PUD13-00001 & SUB13-00015 / Biltmore Company

Summary

Conditional Use Permit for a 168-unit planned residential development with a Preliminary Plat located on 9.21 acres at 1433 N. Raymond Street in C-2D (General Commercial with Design Review) and R-3D (Multi-Family Residential with Design Review) zones.

Planning Division Project Report

SITE PLAN

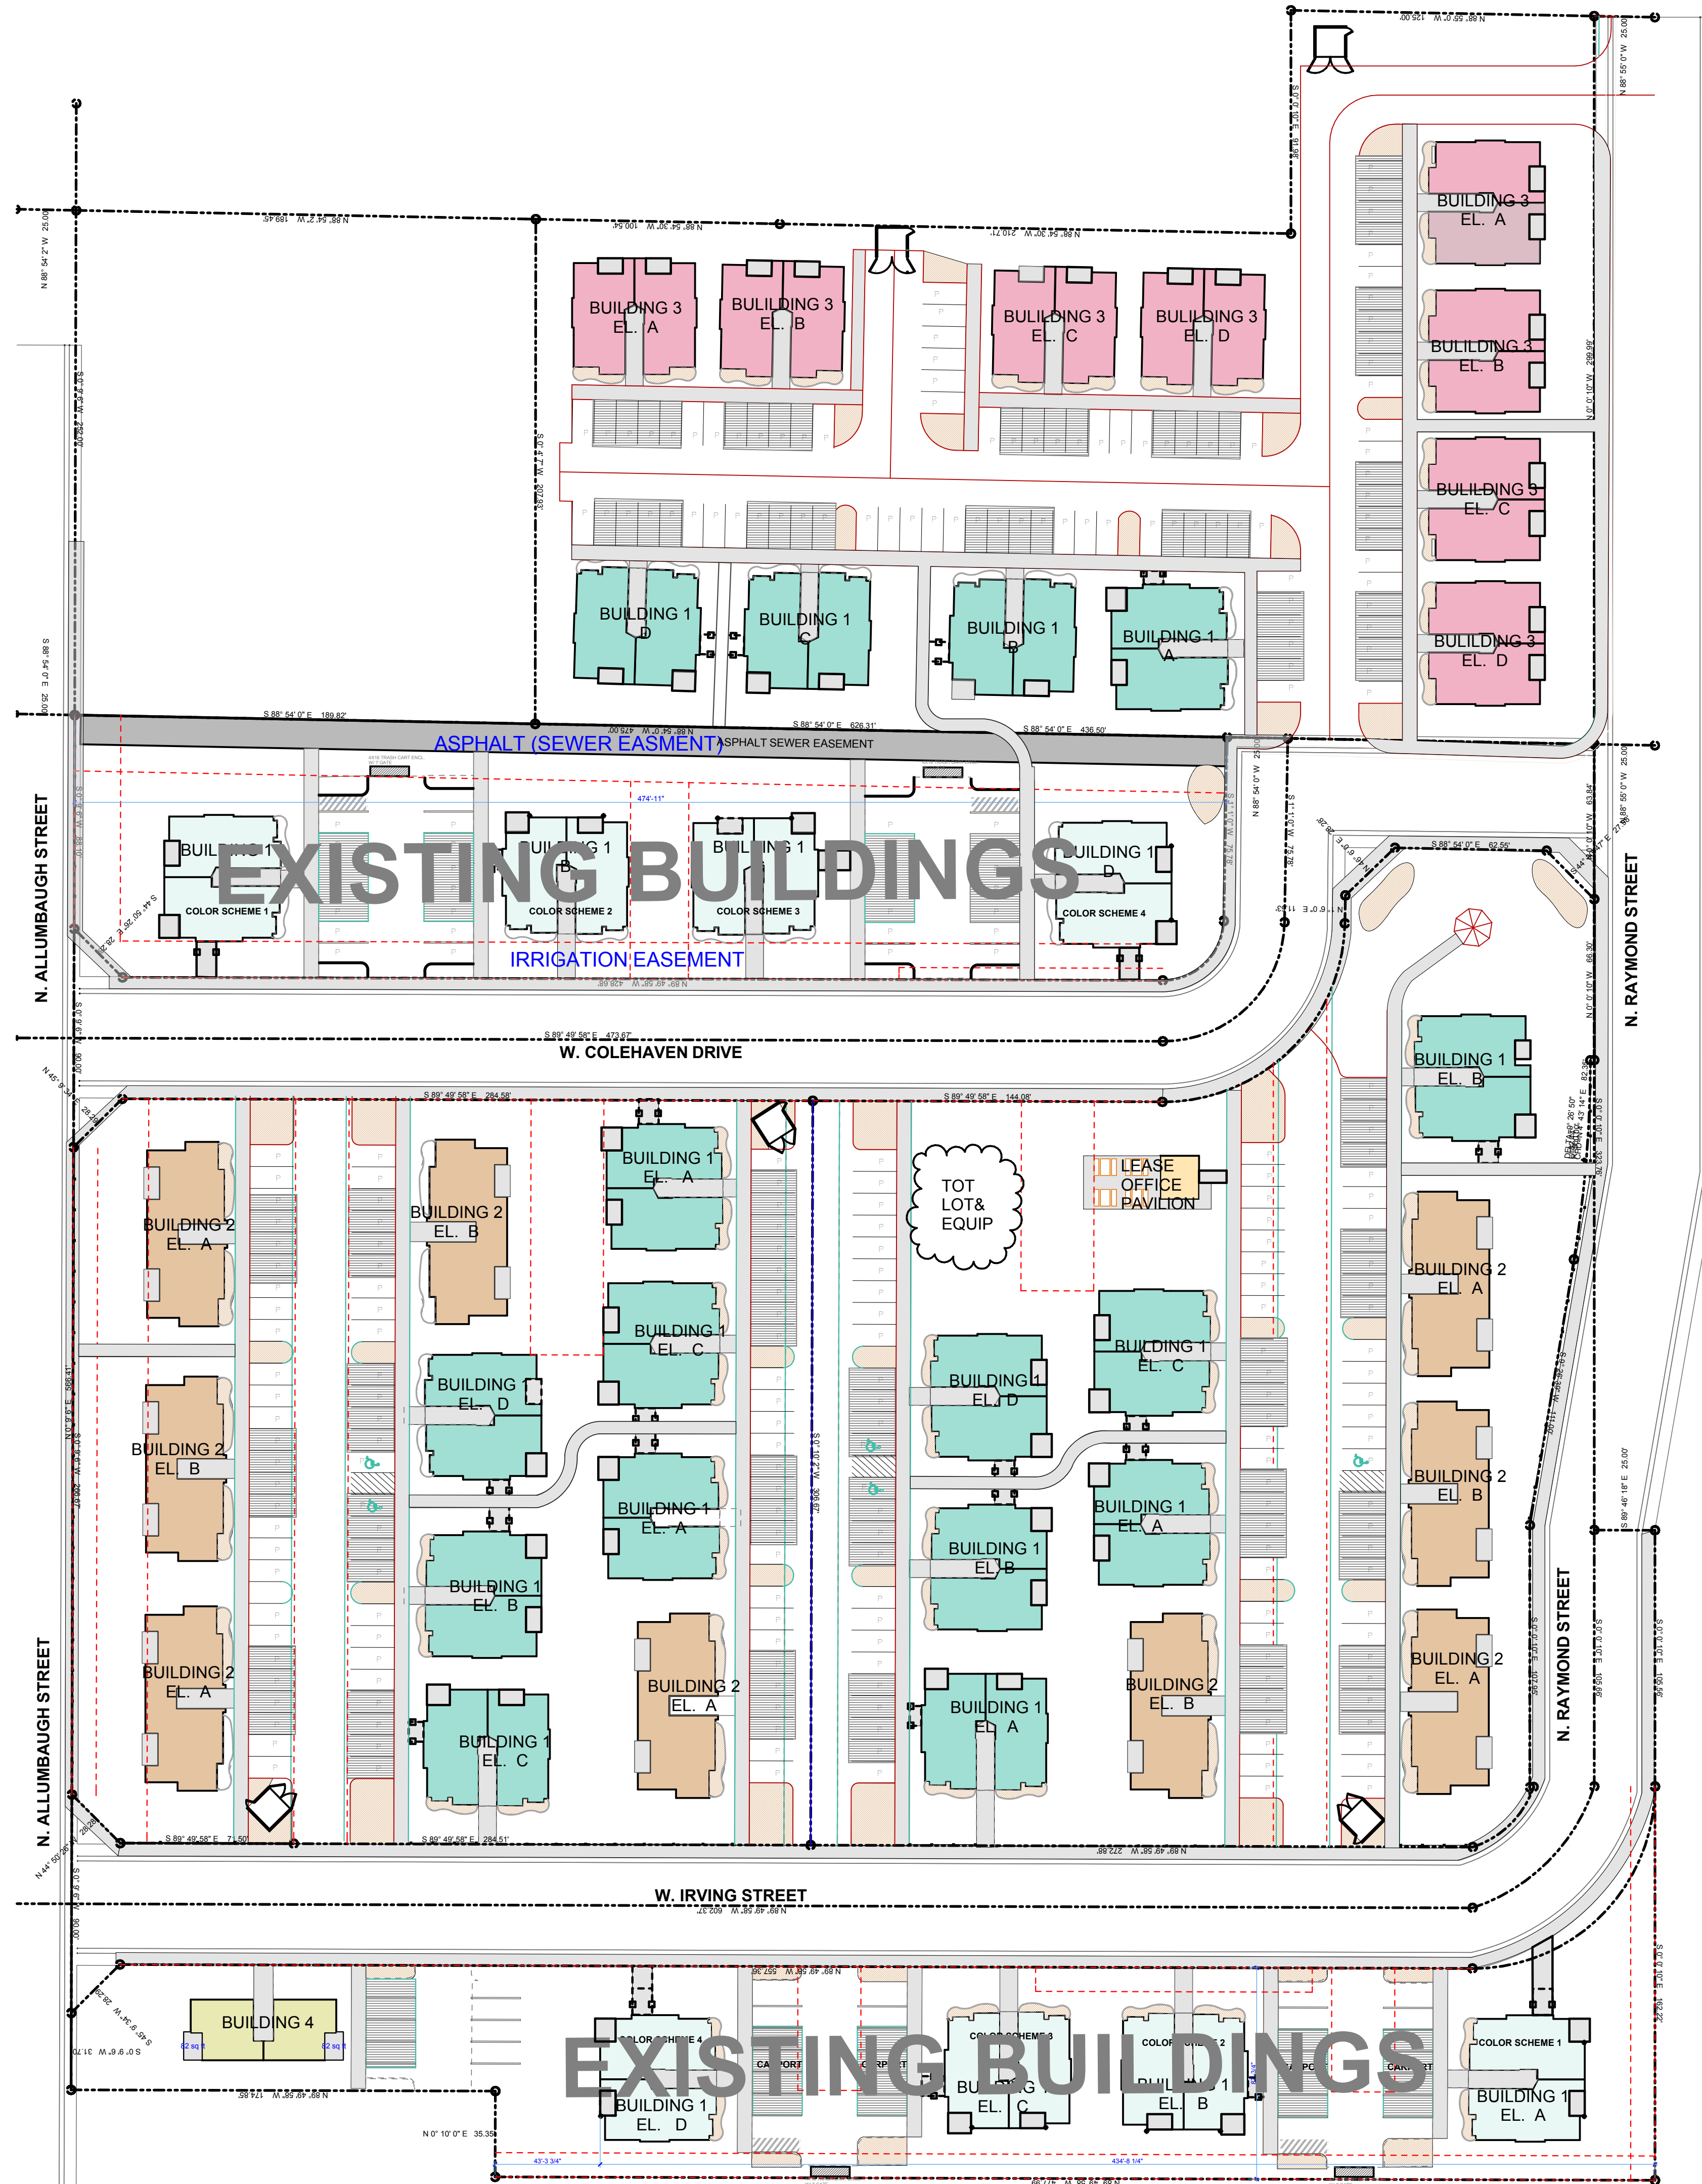
The Comprehensive Plan promotes a variety of product types through *Neighborhoods and Activity Centers Goal 7.1* on sites greater than two acres in size. The project is 9.21 acres in size and is entirely comprised of four-plex units. This is not an ordinance standard at this time but is worth discussing. The neighborhood is already heavily multi-family. The applicant could take the opportunity to provide townhomes or row-houses to introduce more affordable owner-occupied housing into the area or at a minimum provide more varied multi-family. The arrangement of these units provides minimal, if any interface with public streets abutting the site. *Neighborhoods and Activity Centers Goal 12* speaks to providing high quality pedestrian oriented design within the public realm. Primary entrances to the four-plex units should face public streets. These entrances should be covered by a clearly defined roof element. This is included as a recommended condition of approval.

In addition to these concerns, the layout includes large expanses of surface parking with piecemeal open space. There are a variety of options to remedy this that could fulfill previously stated goals of the Comprehensive Plan. Clusters of larger buildings with more units would create more usable communal open space throughout the development. Also this could lead to parking that is more interspersed throughout the project creating a more livable set of units.

This would avoid concentrating too much multi-family development in one area as advocated in ***General Design Principle Neighborhood 3b***. All of the building facades face public streets with rear elevations consisting of sliding patio doors and balconies. The preference in the plan is for entrances facing the street to create a pedestrian oriented environment in accordance with ***General Design Principle Neighborhood 5 and Neighborhood and Activity Centers Goal 12***. To remedy the orientation of the units, a recommended condition of approval will direct Design Review to provide entrances to public streets for every unit possible.

1. Compliance with plans and specifications submitted to and on file in the Planning and Development Services Department dated received **April 30, 2013**, except as expressly modified by Design Review or the following conditions:
2. **Planned Unit Development**
 - a. The primary entrance for each unit shall address a public street wherever possible.
